San Francisco Examiner  
Monarch of the Dailies  
Supreme in Everything

September 18th, 1921.

7/10  
Mr. Hearst's Specifications for Fireplaces

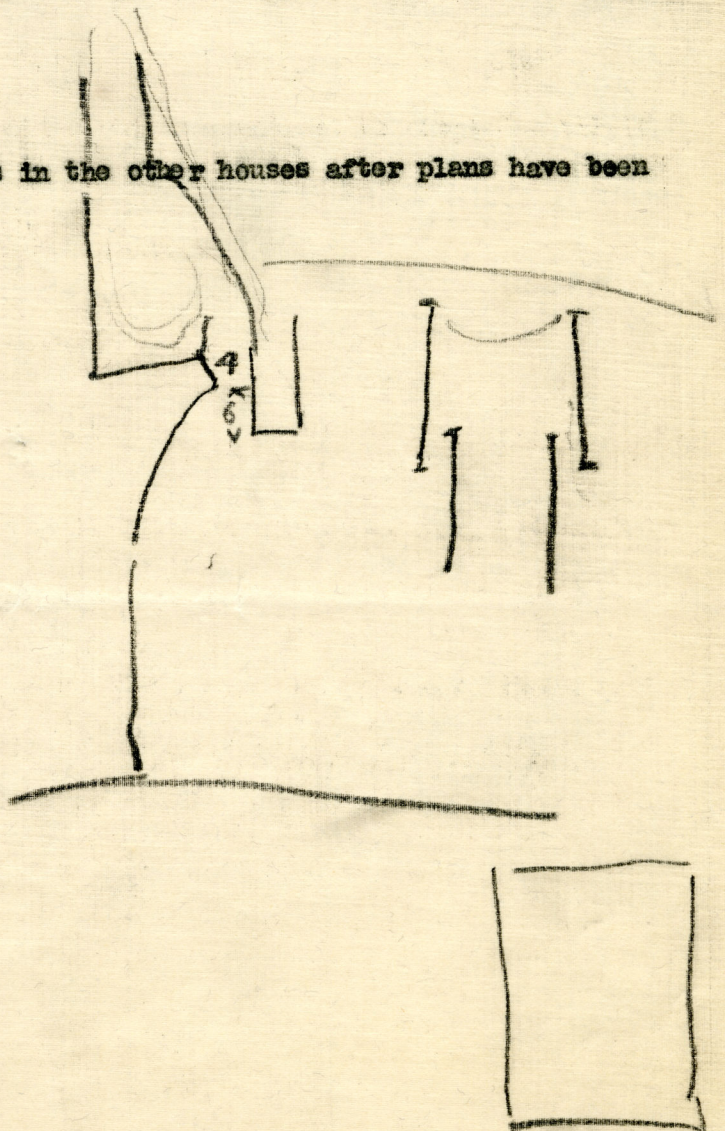
1. Please make fireplace opening wide as possible and low as possible so that width will surely exceed height.
2. Make throat full width of fireplace, all the width that you can get.
3. Make throat four inches deep.
4. Make windshelf not less than eight inches deep.
5. Make windshelf flat as shown in diagram.
6. Use dampers of the kind mentioned in article.
7. Make ample smoke chamber as described in article, converging one foot for every three feet in height.
8. Substitute cylindrical for rectangular flues and make the area of ~~its~~ base  $1/10$  (one tenth) the area of the fire place opening as reconstructed.
9. Carry chimneys high as possible.
